Sterndrive No. 2002-06

## Hydraulic Valve Lifter Adjustment for Mercury Racing Engines

- a** - Allen head set screw
- b** - Adjusting nut
- c** - Push rod
- d** - Box end wrench
- e** - Torque wrench

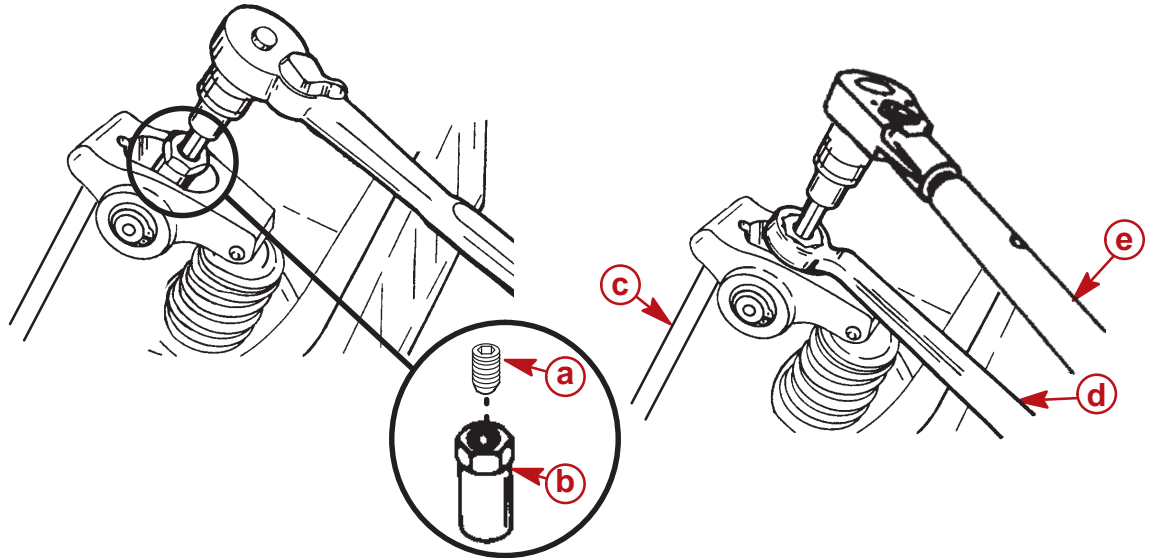
Some Customers have requested clarification of the adjustment procedure for hydraulic lifter assemblies with roller rocker arms. It was also noted that the 500 EFI service manual (90-840283), has an incorrect adjustment procedure as written on page 3A-23.

**IMPORTANT: If the lifter has not been pumped up with oil, the push rod could be rotated while the plunger in the lifter is being collapsed. Any resistance felt while rotating the push rod should be considered no lash. This can be checked by making sure there is no up and down movement of the push rod or zero clearance between the rocker arm and valve stem.**

2. When the engine is at number 1 TDC, adjust the following valves: **Exhaust - 1-3-4-8, Intake - 1-2-5-7.**
3. Loosen Allen head set screw.
4. Loosen the adjusting nut until lash is felt at the push rod, and then tighten the adjusting nut until all lash is removed. Lash can be checked by rotating the push rod while hand tightening adjusting nut until all play is removed.

5. Rotate adjustment nut an additional, three quarter turn (270°) for roller camshafts or five eighths turn (225°) for flat tappet camshafts.
6. While holding adjusting nut in position, torque Allen head set screw to 34 Nm (25 lb-ft).
7. Using a wrench on the crankshaft pulley center bolt, turn the engine over in the normal direction of rotation while placing a finger over the number 6 cyl. spark plug opening. There should be compression felt at the spark plug opening for number 6 cylinder as 0° TDC is approached. If not, the engine is in the number 1 firing position and should be turned over one more time, 360°, to reach number 6 position 0° TDC.
8. When the engines is at number 6 TDC, adjust the following valves: **Exhaust - 2-5-6-7, Intake - 3-4-6-8.**
